California High-Speed Train Project

**RFP No.: HSR 11-16
Design Variance Report**

FRESNO STATION CROSSOVER DISTANCE FROM STATION
HST TRACK ALIGNMENT SPIRAL/VERTICAL CURVE OVERLAP
OCS CLEARANCE ASHLAN AVE
OCS CLEARANCE UNDER FUTURE RECONSTRUCTED FRESNO YARD OVERHEAD

DESIGN VARIANCE COVER SHEET

1"=100' HOR
 SCALE APPLICABLE FOR FULL SIZE ONLY
 1"=10' VERT
 SCALE APPLICABLE FOR FULL SIZE ONLY

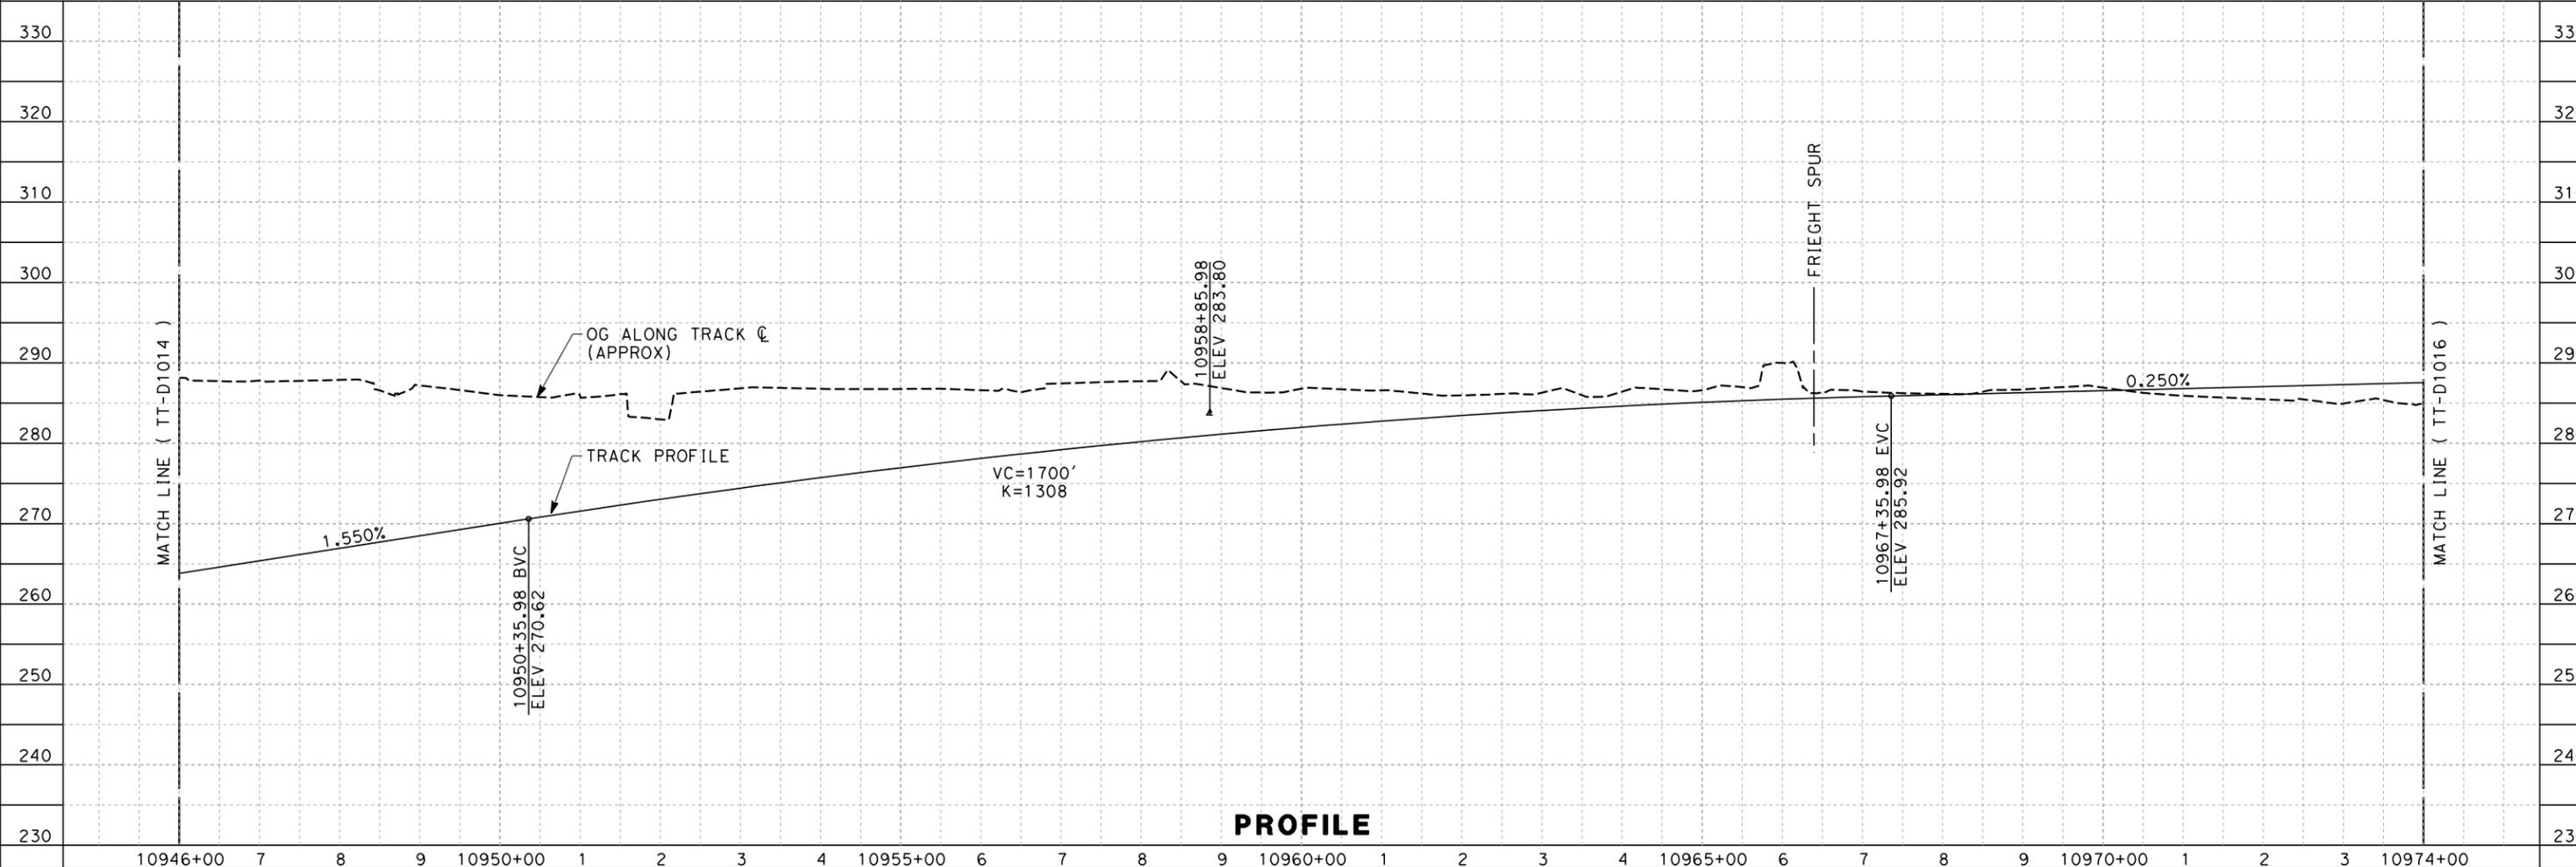
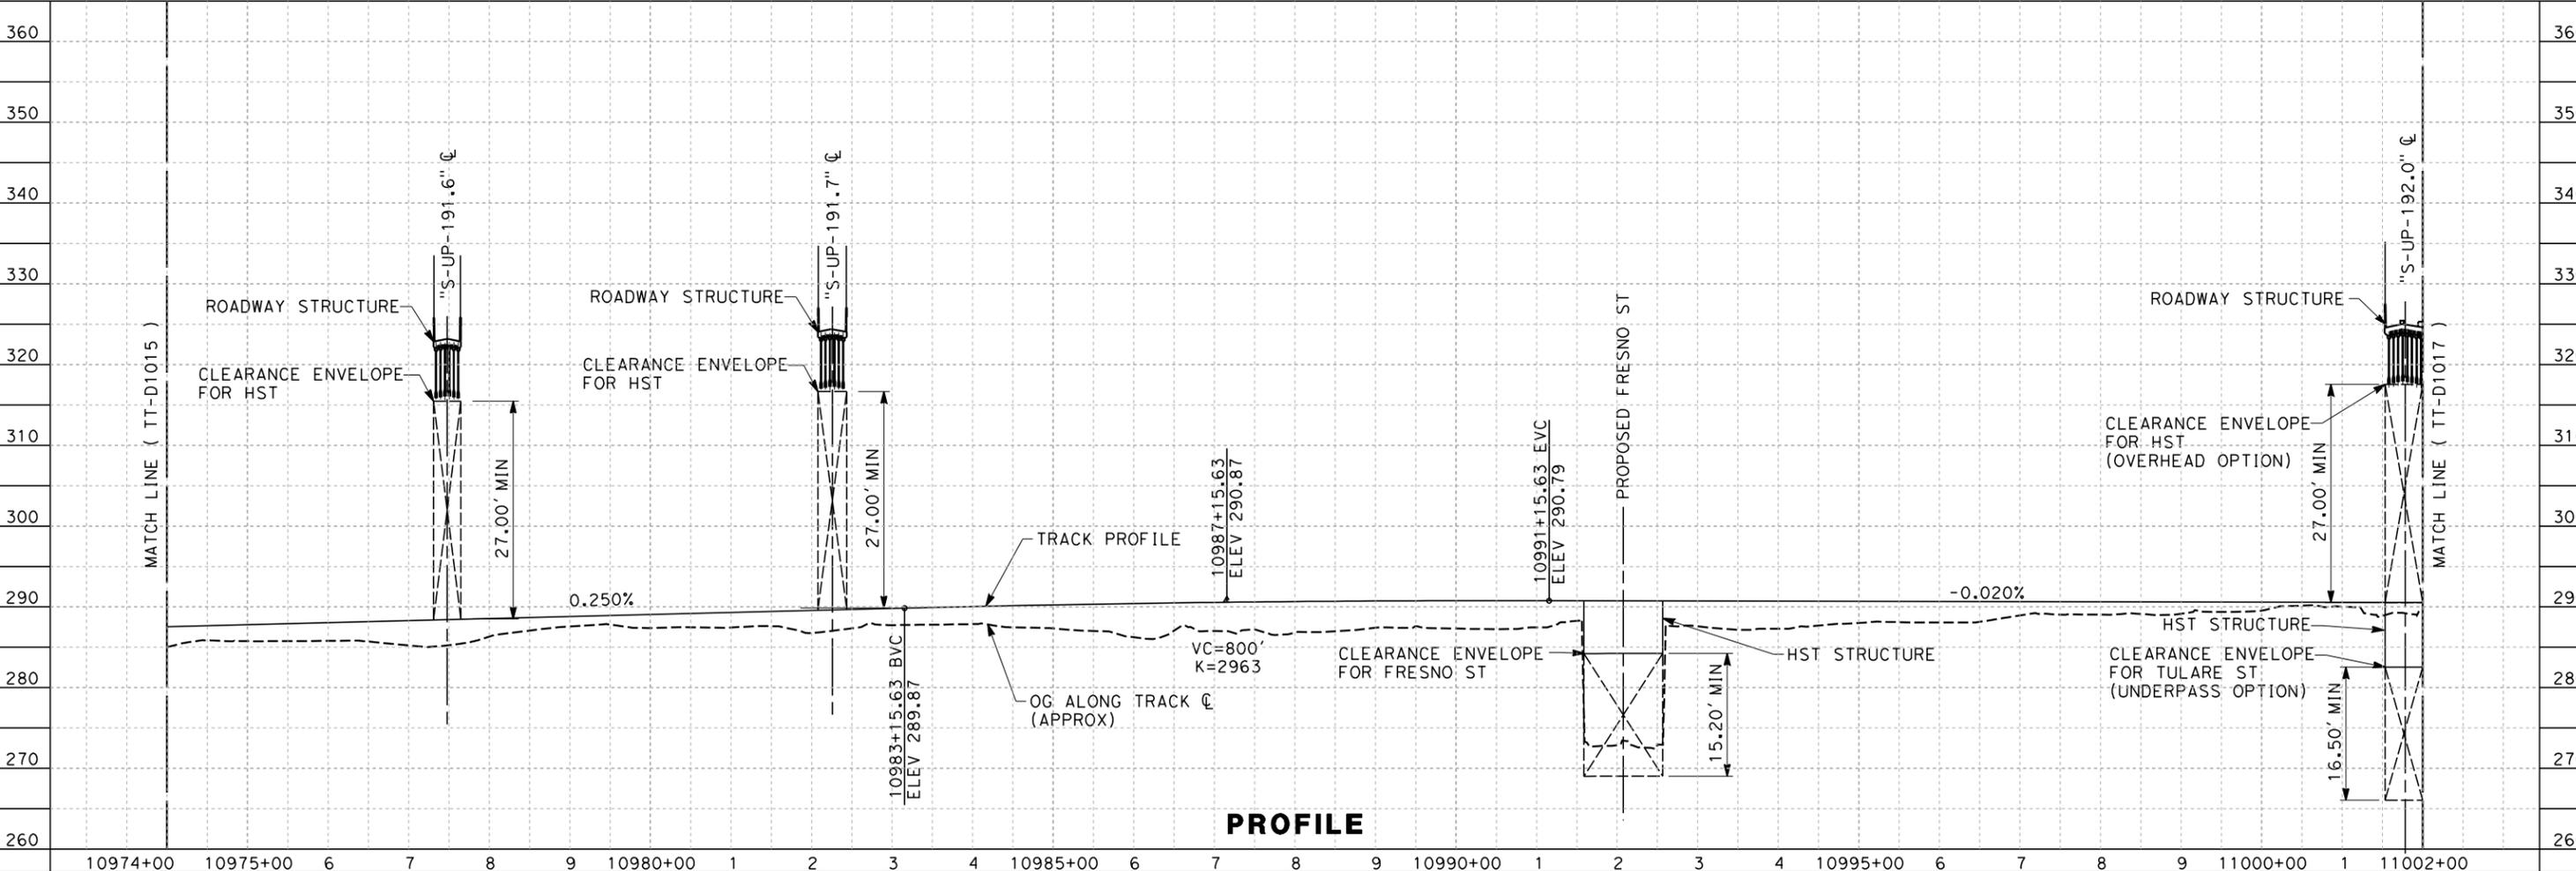
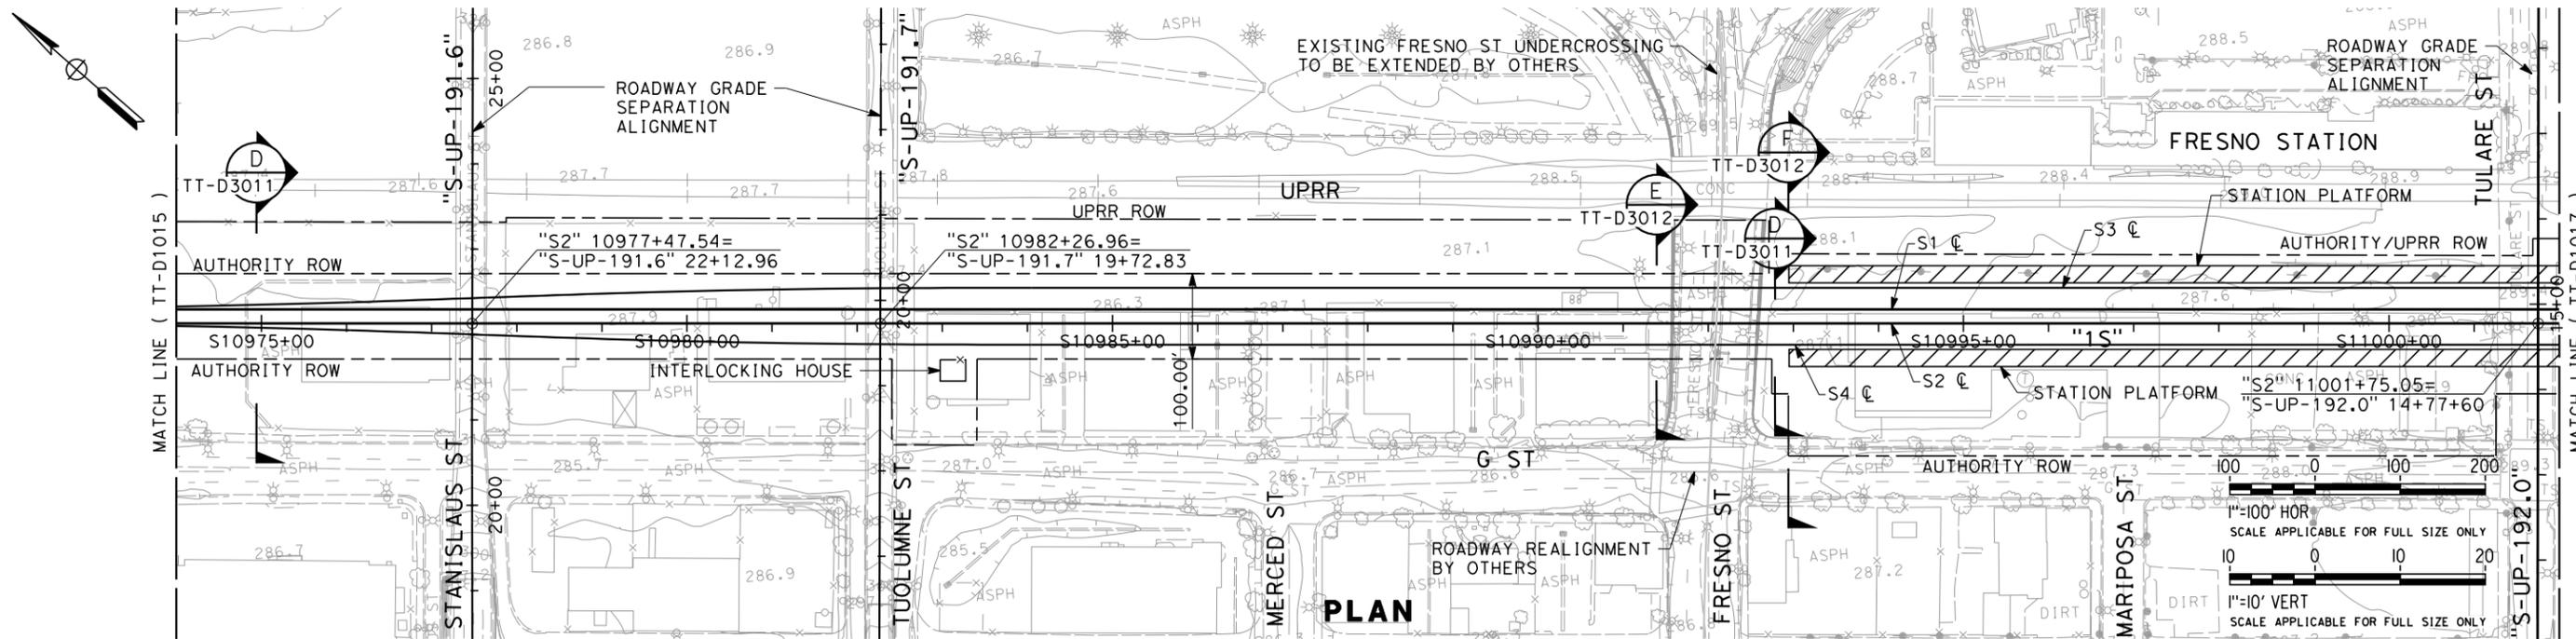
<p>CHSTP DESIGN REQUIREMENT Include reference to drawings, design criteria, technical memos, specifications</p>	<p>TM2.1.3 – Turnouts and Station Tracks Rev 0, 06/29/09 Figure 6.1.4 stipulates the desirable run time to determine the “minimum distance between the end of station turnout and crossover turnout, where they are on the same track,” should be 1.5 seconds, or a minimum of 1 second.</p> <p>Verbal advice from EMT stated that station crossovers should not be more than a mile from the station.</p>
<p>DESIGN CRITERIA REQUIRING A VARIANCE</p>	<p>Desirable run time to determine the “minimum distance between the end of station turnout and crossover turnout, where they are on the same track,” should be 1.5 seconds, or a minimum of 1 second.</p>
<p>REASON FOR REQUESTING A VARIANCE</p>	<p>Crossovers for Fresno stations at STA 10851+72.74 to 10863+11.37 and 108664+61.37 to 10876+00.00. Station platform ends are at 10970+00. This is a maximum separation of 14,127ft.</p>

<p>JUSTIFICATION FOR VARIANCE</p>	<p>Fresno Station is centered on Mariposa St and the station platform track approaches extend from Stanislaus St to the north and Santa Clara St to the south. The high-speed rail (HSR) descends into trench immediately after Stanislaus St in order to cross under abutments supporting the SR180 overcrossing of the Union Pacific Railroad (UPRR) tracks, spur tracks belonging to the San Joaquin Valley Railroad (SJVR) Company, and a canal that crosses under both the UPRR and the SJVR.</p> <p>The HSR is on a vertical curve as the tracks descend into the trench followed by a constant gradient of only 800ft at a gradient of 1.550%, followed by another vertical curve and then another section of 1,000ft at a constant gradient of -1.900%. The HSR emerges from the trench and is back at-grade on a constant gradient of 0.110% around 9,000ft (1.7 miles) to the north of the station platform turnouts. There are no sufficiently long sections at a constant gradient within the trench to accommodate a crossover with a design speed of 110mph (i.e., 1,139ft).</p>

<p>PROPOSED ALTERNATIVE DESIGN</p>	<p>Continue an at-grade alignment between W</p>

REQUIREMENT	<p>Olive and the station. This would require grade separation junction to carry the SJVR spurs (if feasible) and closure of Dry Creek. SR180 would require major works to the embankments and probable reconstruction of the abutments of the bridge crossing UPRR.</p> <p>It may be feasible to provide a crossover on the 1,000-foot section of constant gradient within the trench, but this would require the imposition of an 80mph speed restriction due the short crossover. This option was not recommended.</p>
--------------------	--
